Letter of Response

**RE: 35-41 Wilfred Barrett Dr, THE ENTRANCE NORTH NSW 2261
Development Application DA/308/2011**

We refer to the comments from the JRPP meeting dated 17 May 2012. We have since tested a few design options in response to issues raised by the JRPP and we have had a meeting with Wyong Council on 20th June 2012 to discuss the best design outcome. This letter accompanies the revised architectural plans Issue E.

Revised External Finishes Schedule

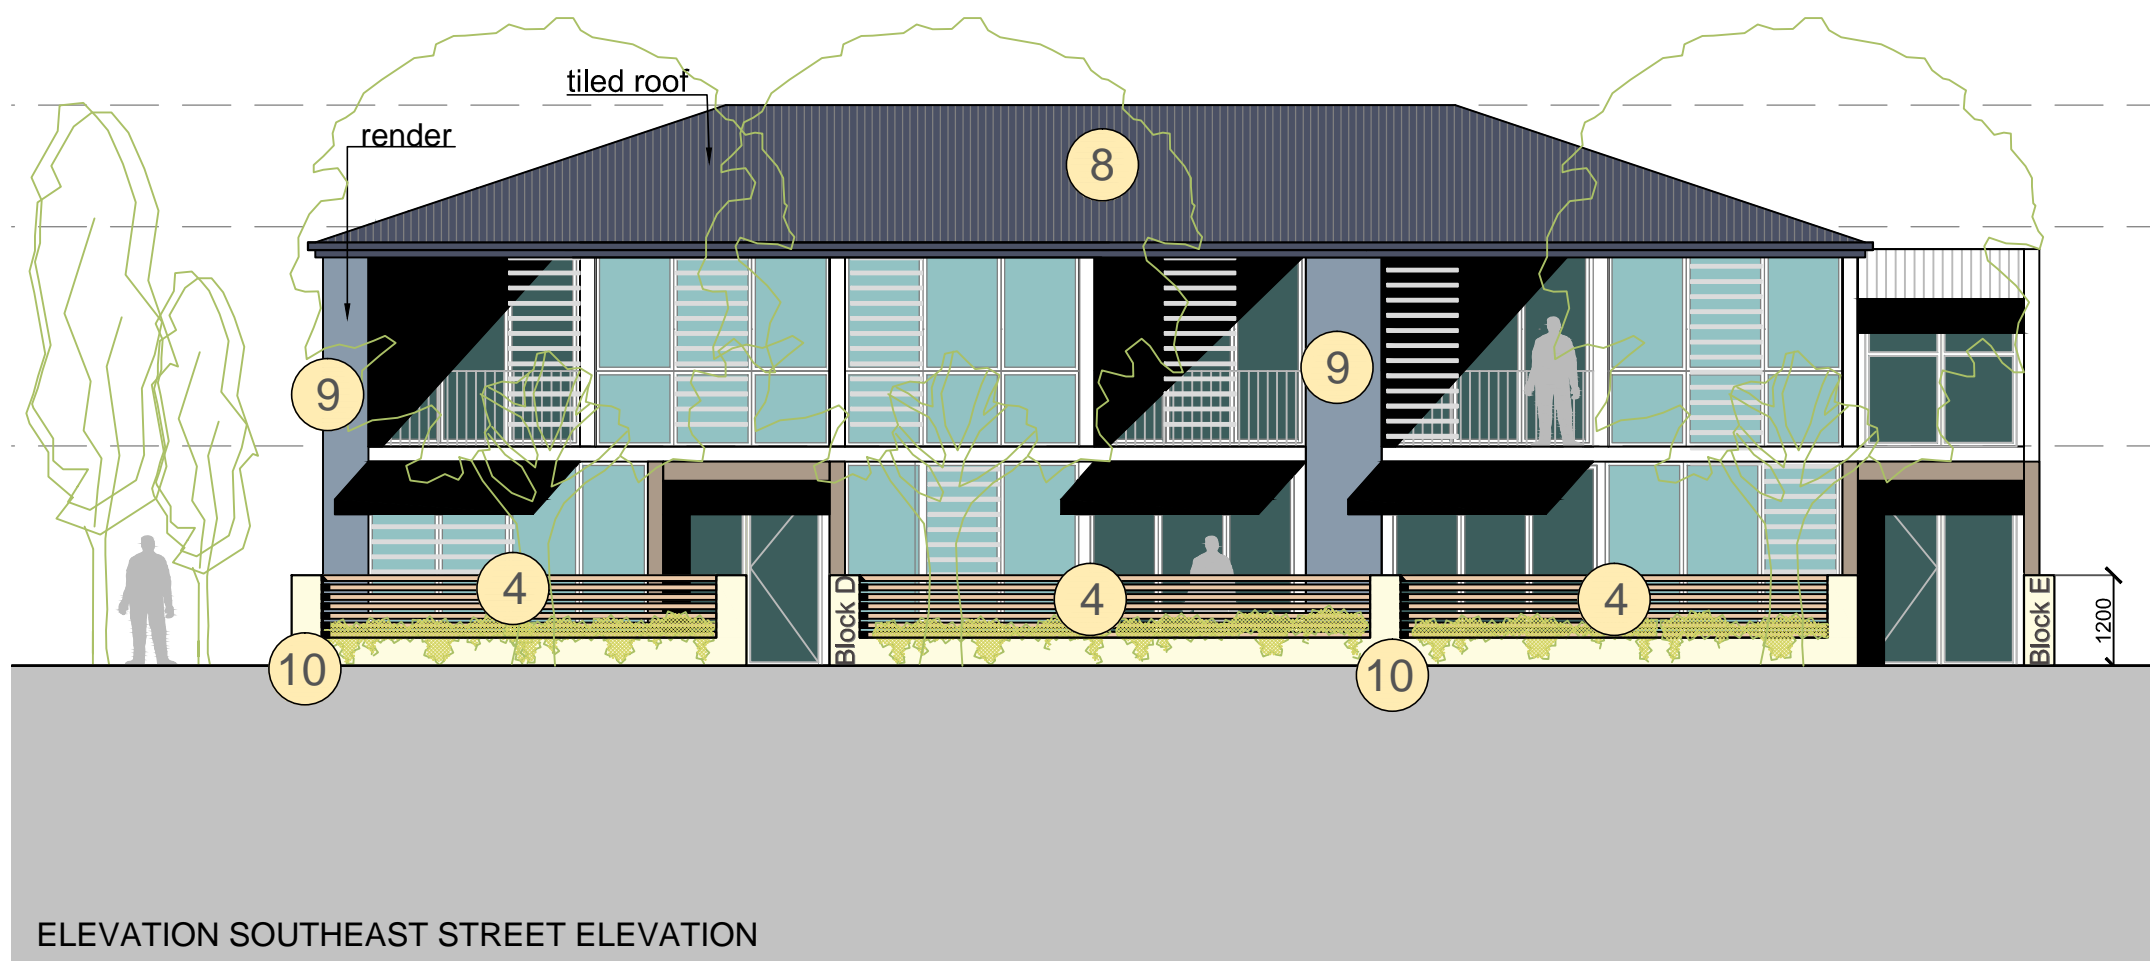
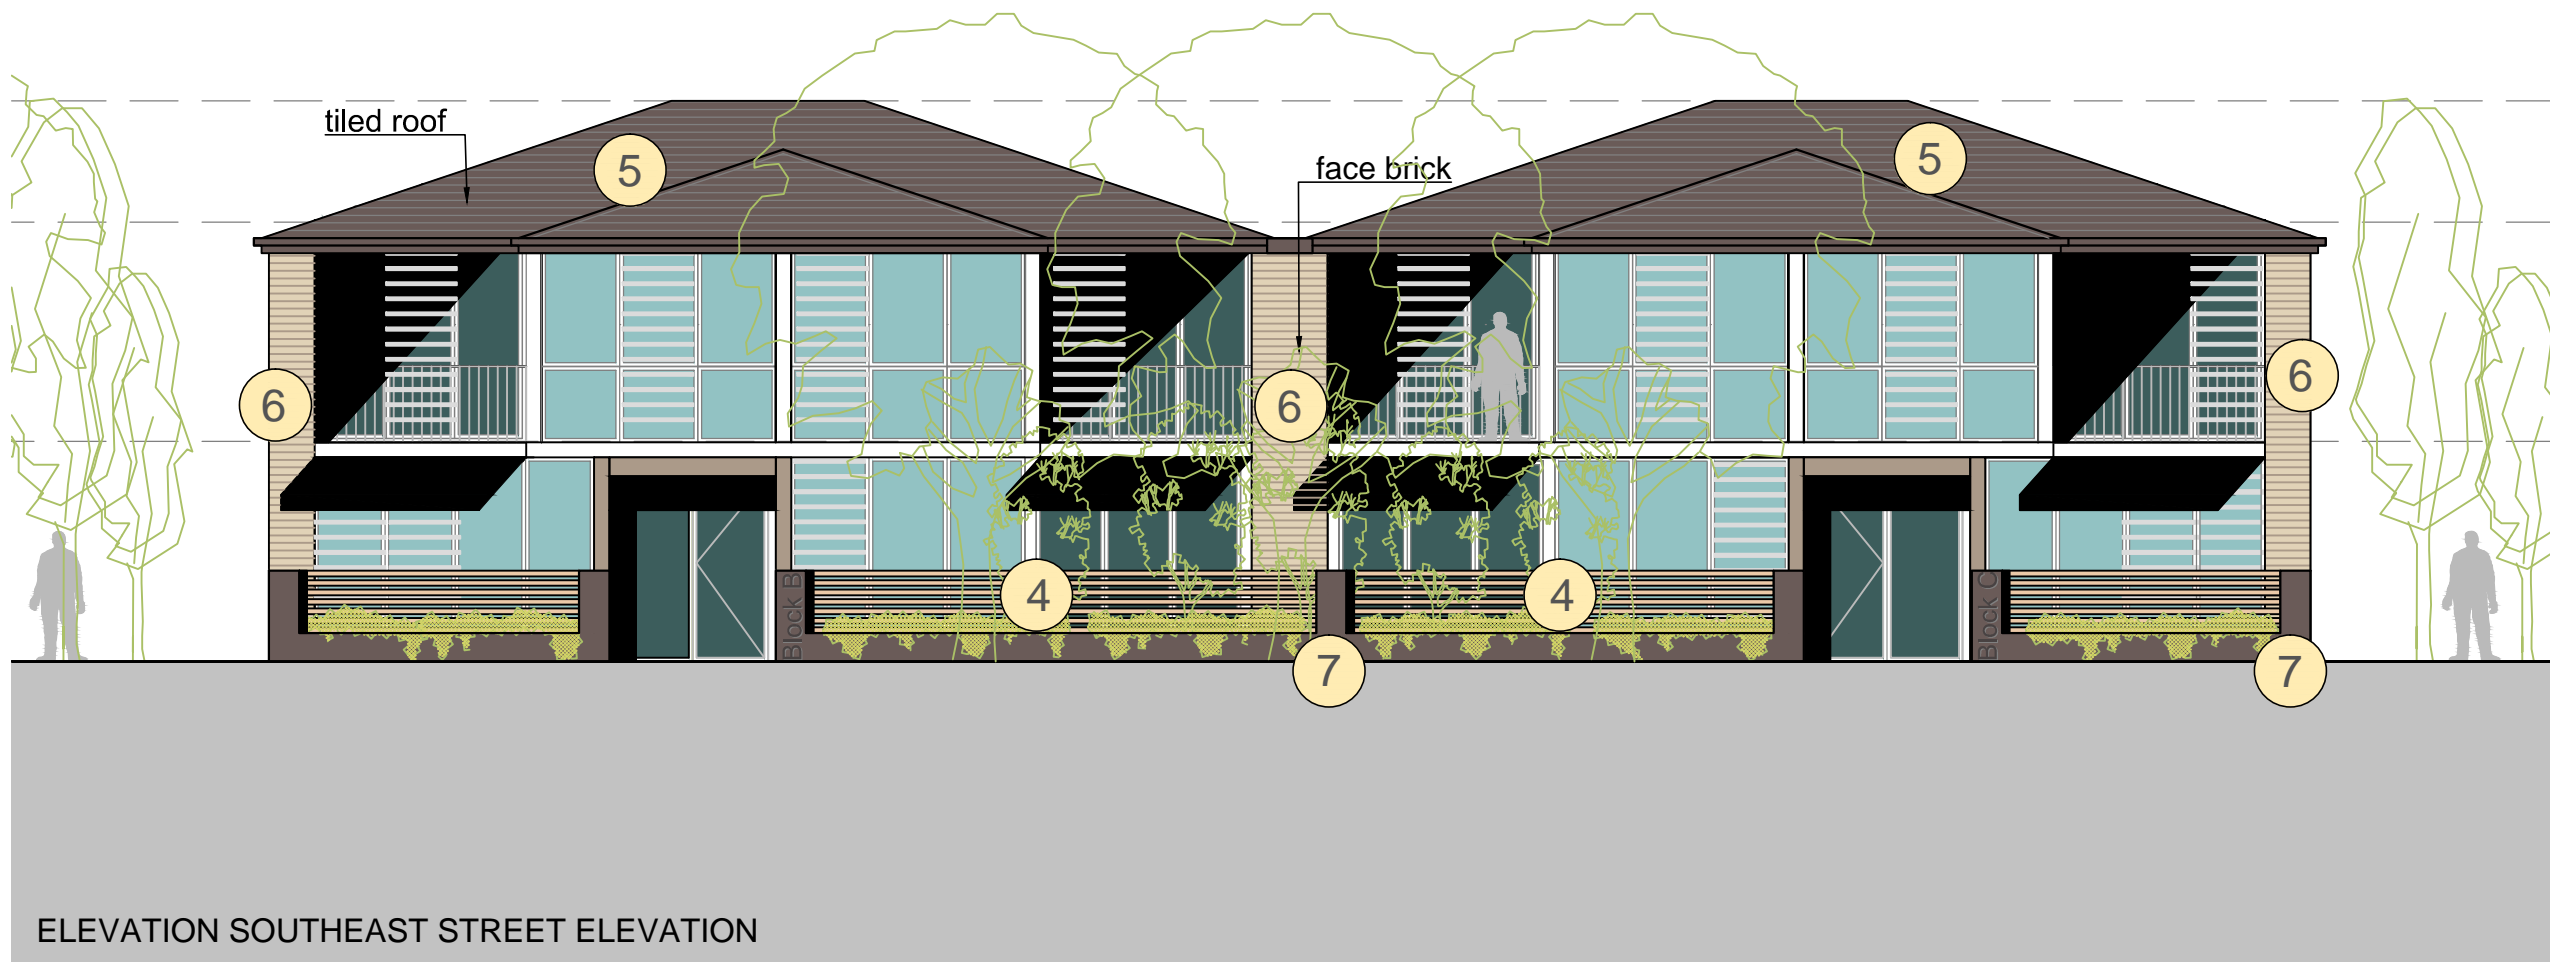
As shown in DA09-Issue E, the building façade proposed usage of different materials and finishes to differ each proposed building. Various finishes proposed are dark brown render, natural color face-brick, and ocean blue render for the 3 different street front buildings (*refer to appendix 4 for revised external schedule of finishes*).
